## SINGAPOREAN NOTICES TO MARINERS

I  
**AFFECTED CHARTS AND PUBLICATIONS**

CORRECTION NO.	SNM EDN NO.	LAST CORR NO.	CHART NO.	Location on Chart		
56 (2)	12/2022	37	201			X

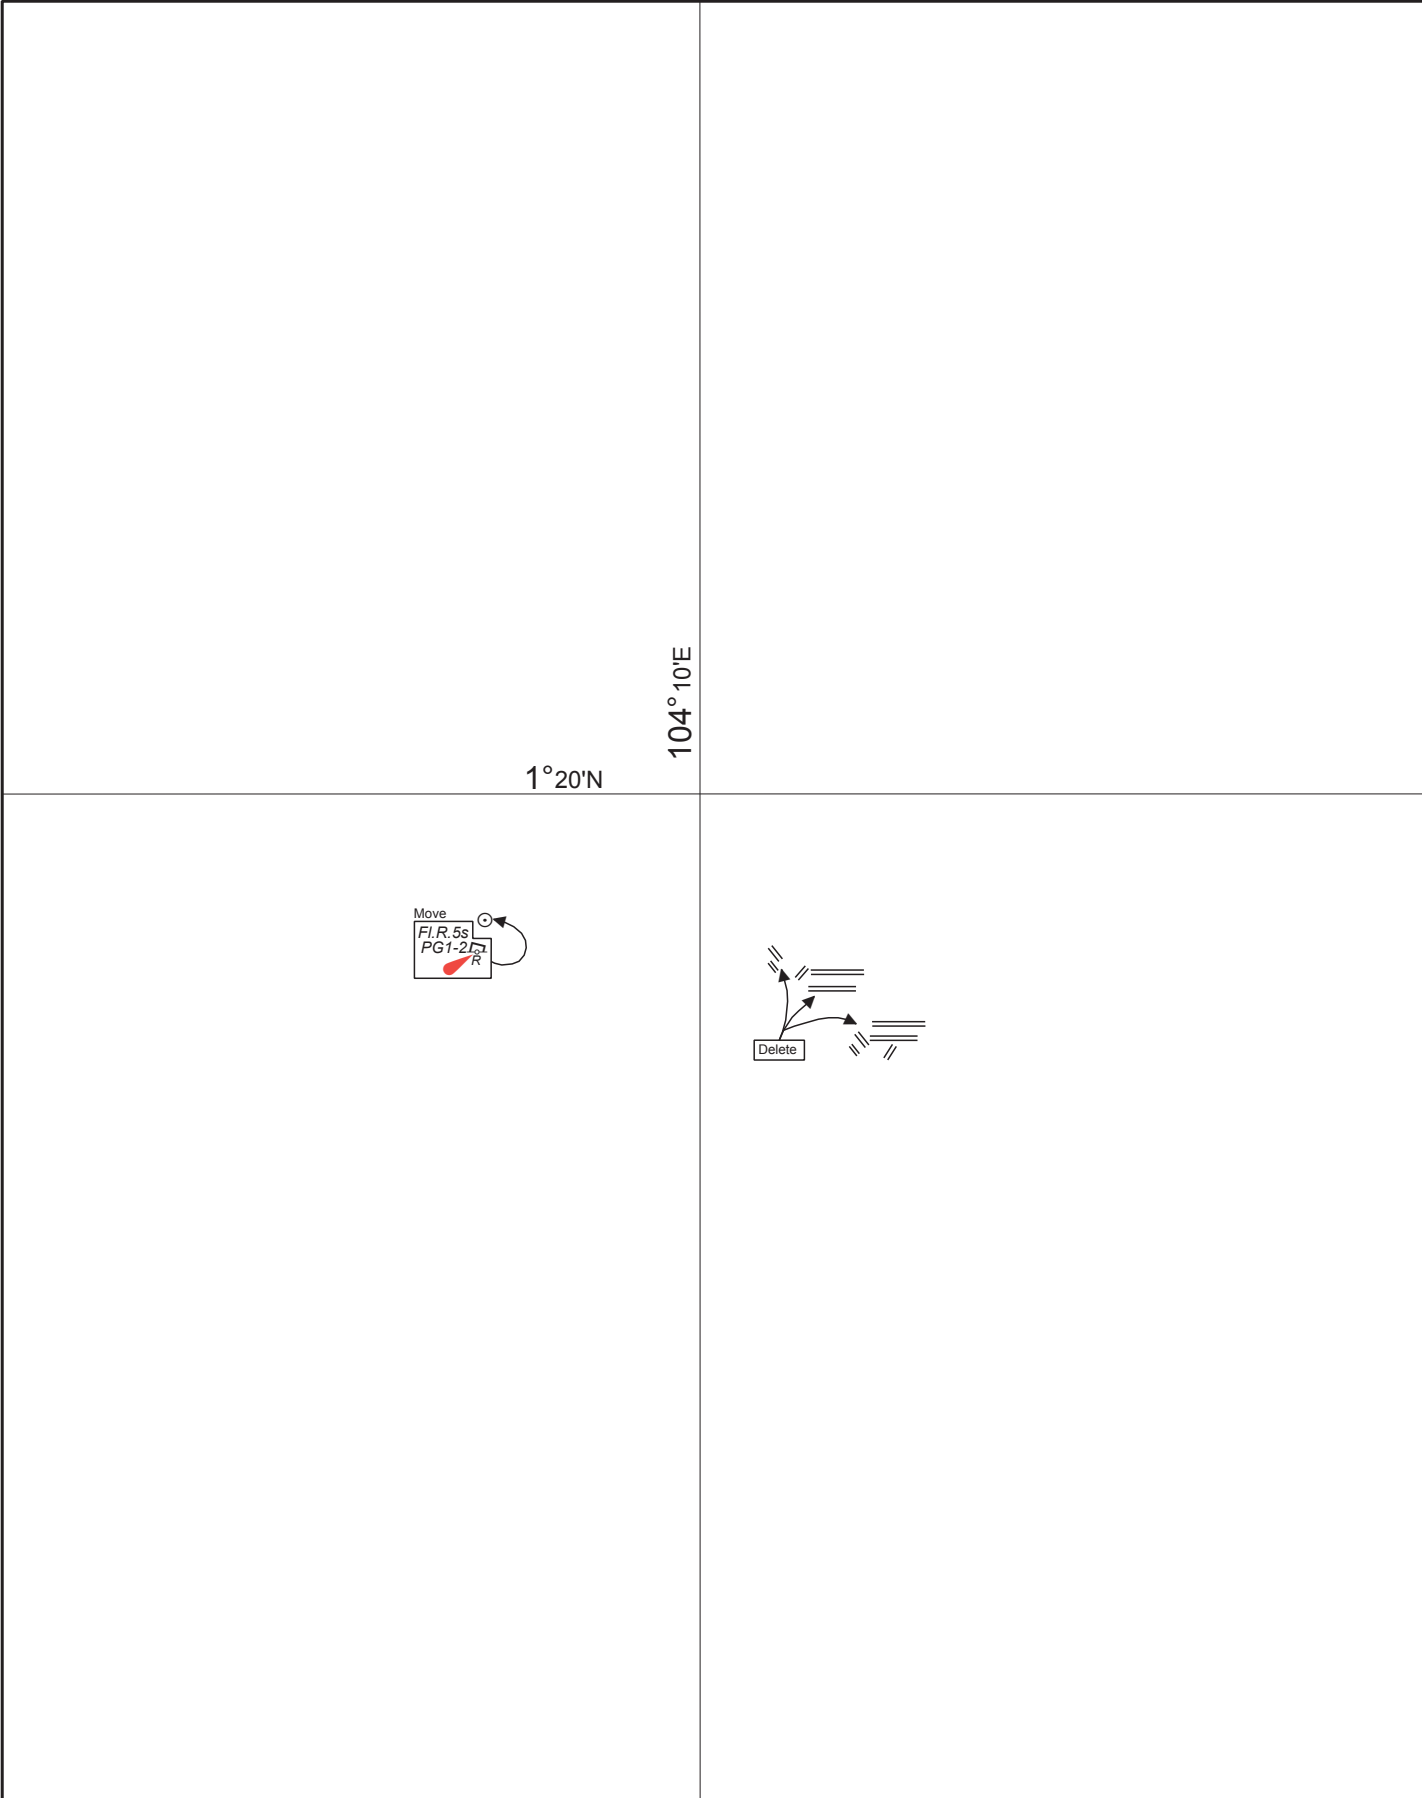
**Delete**  *PA* 1°20·42'N 102°52·10'E
